ADDENDUM

PROJECT: Forestside Estates
Attmar & Palleschi Drive
Brampton, Ontario

PROJECT NO.: 18-017

ADDENDUM NO. M-1

TITLE PARKING LEVEL - PLUMBING MECHANICAL	
PROJECT BRAMPTON STACKED FORESTSIDE ESTATES	
ATTMAR + PALLESCI DRIVE BRAMPTON, ONTARIO	
DRAWN MC	CHECKED LM
DATE MAY, 2019	SCALE 1:150
PROJECT 18-017	
DRAWING M-3	
OF

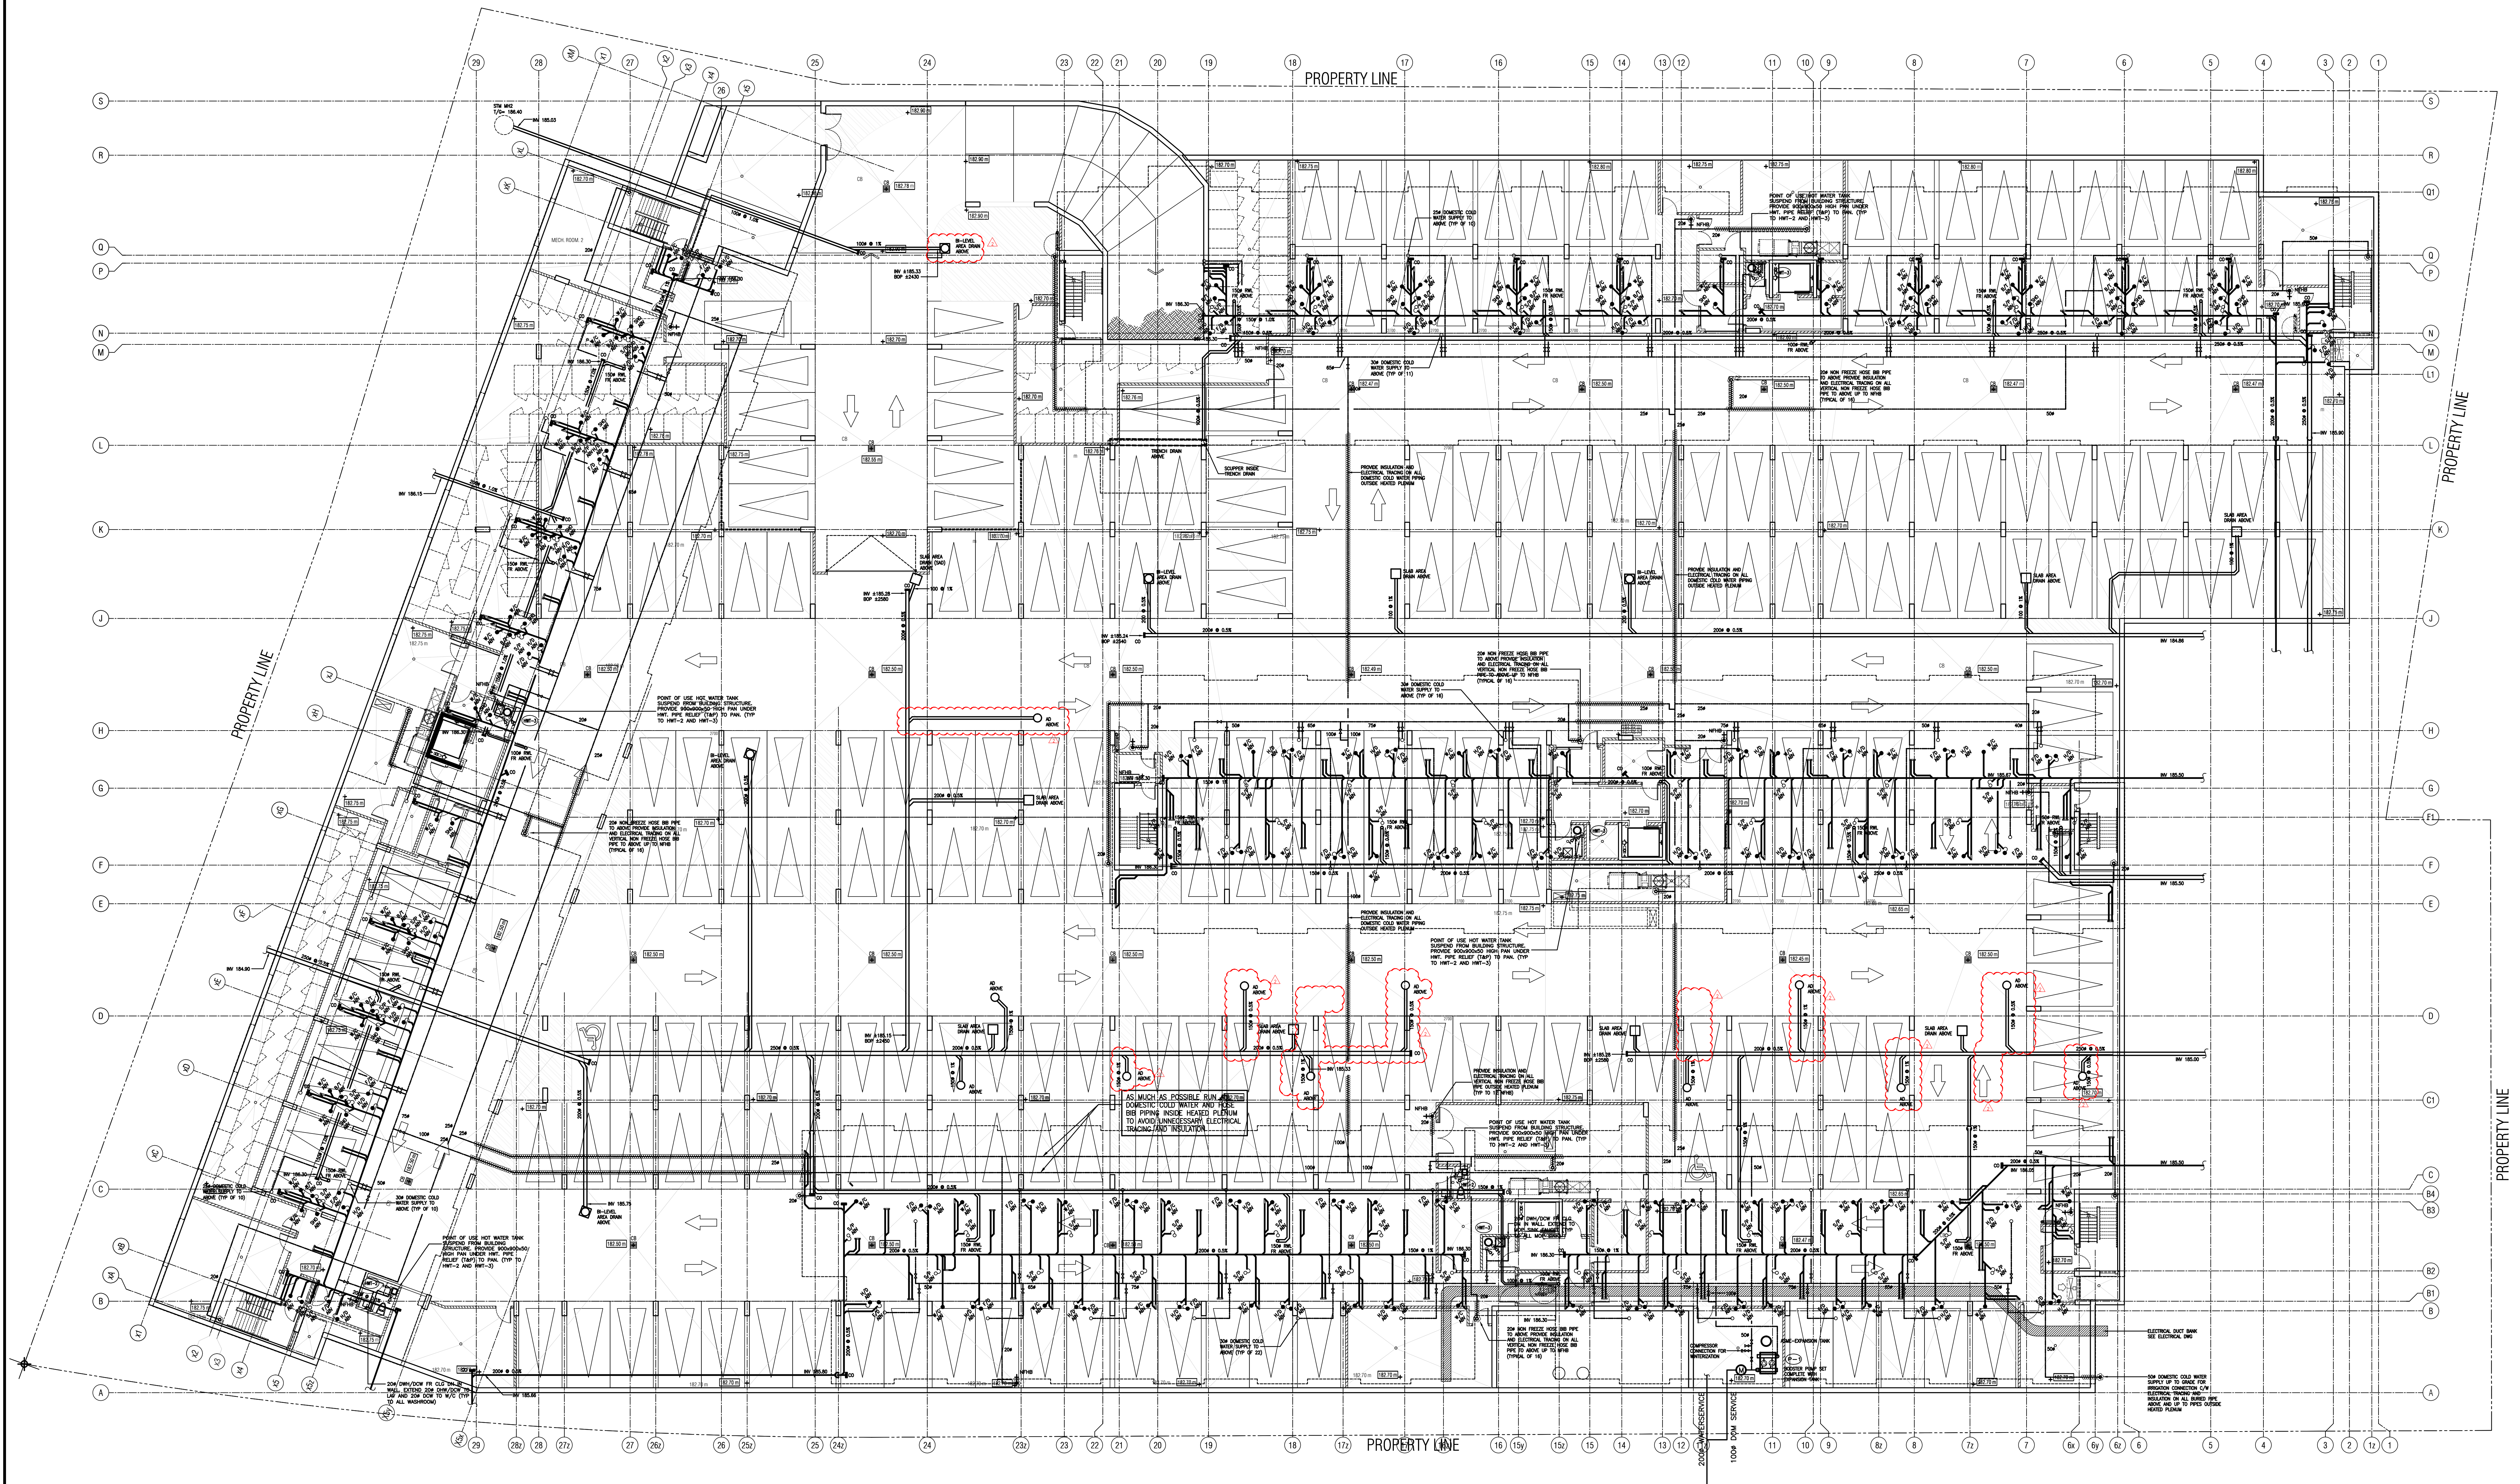
1.0 Mechanical drawing M-3 (Ground Floor Plan Overall- Mechanical) Issued

1.1 Revised: Area drain location & corresponding storm piping connection.
